Access Compliance Report
Public Rights-of-Way
(Curb Ramps)

Intersection ID: 15409	**Main Street: LEDGEWOOD_LN**	**Cross Street: SARAH_MARKS_AV**	**Location: W**
ADA ID: 20940AC8BBF7	**Ramp Type: Perp**	**Initial Pass/Fail: Fail**	**Overall Compliance: No** / **Severity Score: 46.25**

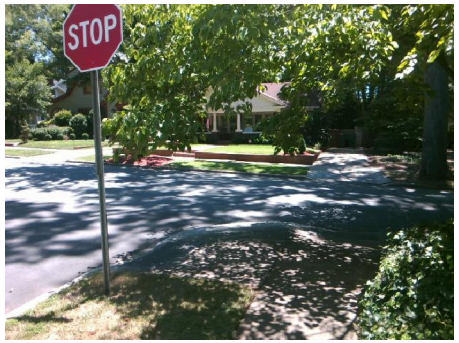
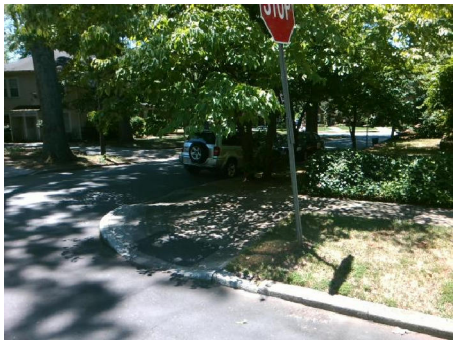
Not Found, R304.5.1, R304.2.2, R304.5.3

Compliance	Description	Data	Compliance	Description	Data
N/A	Ramp Length (in)	77.0	No	Ramp Slope (%)	9.3
No	Ramp Width (in)	40.0	No	Ramp XSlope (%)	8.4
N/A	Flare Type LT	N/A	N/A	Flare Type RT	N/A
N/A	Flare Slope LT (%)	N/A	N/A	Flare Slope RT (%)	N/A
N/A	Flare Traversable LT?	N/A	N/A	Flare Traversable RT?	N/A
N/A	Landing Length (in)	N/A	N/A	DWS Provided?	N/A
N/A	Landing Width (in)	N/A	N/A	DWS Contrast?	N/A
N/A	Landing Slope (%)	N/A	N/A	DWS Length (in)	N/A
N/A	Landing X Slope (%)	N/A	N/A	DWS Full Width?	N/A
N/A	Landing Curb? (Y/N)	N/A	N/A	DWS Offset (in)	N/A
N/A	Shared Landing?	N/A			
N/A	Gutter Ponding?	N/A	N/A	Gutter Slope (%)	N/A
N/A	Gutter Lip Ht (in)	N/A	N/A	Gutter X Slope (%)	N/A
N/A	Painted X Walk1?	No	N/A	Painted X Walk2?	N/A
	X Walk 1 Direction	To NE		X Walk 2 Direction	N/A
N/A	X Walk 1 Width (in)	N/A	N/A	X Walk 2 Width (in)	N/A
	X Walk 1 Slope (%)	4.8		X Walk 2 Slope (%)	N/A

Remove & Replace Entire Ramp.
